Planning Commission
February 20, 2024 - 6:00 PM
233 South Main Street, Monroe, Ohio

- Case No. 2024-2-1 – Consideration of a site plan for Dollar Tree

I. Case No. 2024-2-1— Consideration of a Site Plan for Dollar Tree

Location of the required landscaping along the access drive highlighted in blue.

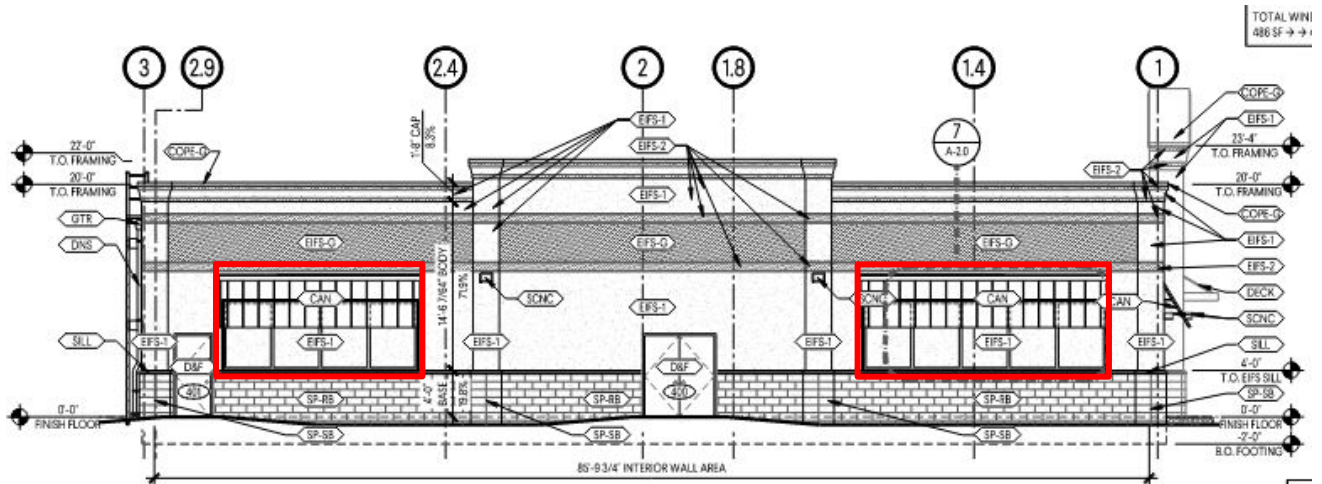
- i. The applicant has requested to use existing vegetation to meet this standard along the rear access drive.

- ii. The existing vegetation does not meet the code requirement for landscaping in this area as there is no discernable landscaping in this area.

Please revise the landscape plan to show the required landscaping along the rear access drive.

Northeast Elevation

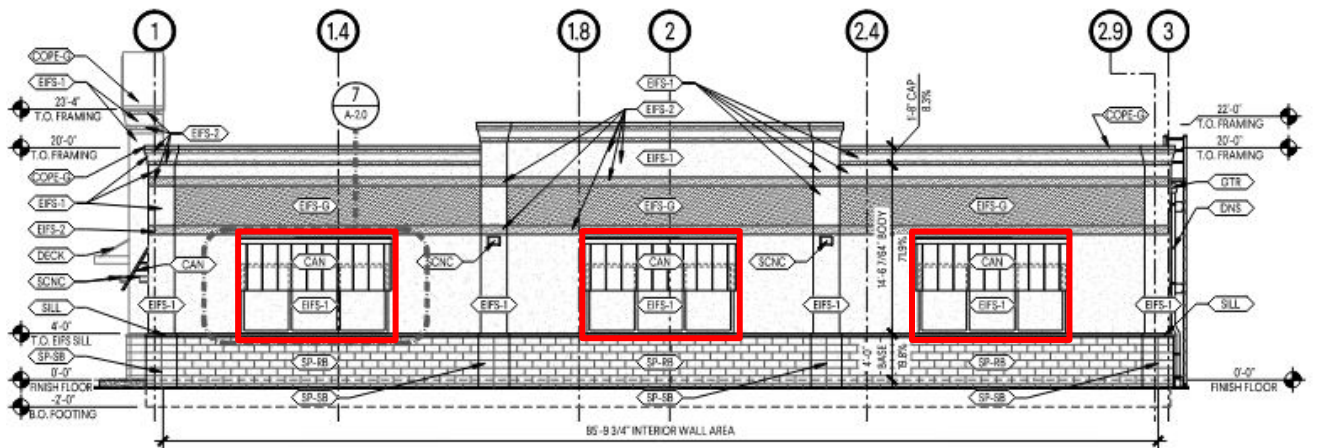
1. The bottom edge of the windows shall not be higher than 3 FT above grade on the ground floor.
 - The elevations appear to show the windows being 4 FT above grade. Please revise.
2. The applicant has submitted an Alternative Compliance application in addition to the Site plan application. The applicant is requesting alternative equivalent compliance for the window requirements on the northeast and southwest elevations.
 - As a reminder, elevations visible from a right-of-way are required to contain at least 25% windows calculated by overall wall area.
 - i. The applicant proposes to use a fabricated metal canopy and EIFS FEAUX which will be colored to give the appearance that it is matching the framing and glazing used on the front elevation. (highlighted in red below)
 - ii. This combination of canopy and EIFS will equal 25% of the wall area on both facades.

- The review criteria for the alternative compliance are as follows:

- i. The proposed alternative achieves the intent of the subject design or development standard to the same or better degree than the subject standard;
 - ii. The proposed alternative achieves the goals and policies of the comprehensive plan to the same or better degree than the subject standard;
 - iii. The proposed alternative results in benefits to the community that are equivalent to or better than compliance with the subject standard; and
 - iv. The proposed alternative imposes no greater impacts on adjacent properties than would occur through compliance with the specific requirements of this code.
- Staff believes that the alternative compliance may not achieve the intent of the subject design or development standard to the same or better degree than the current architectural standards.
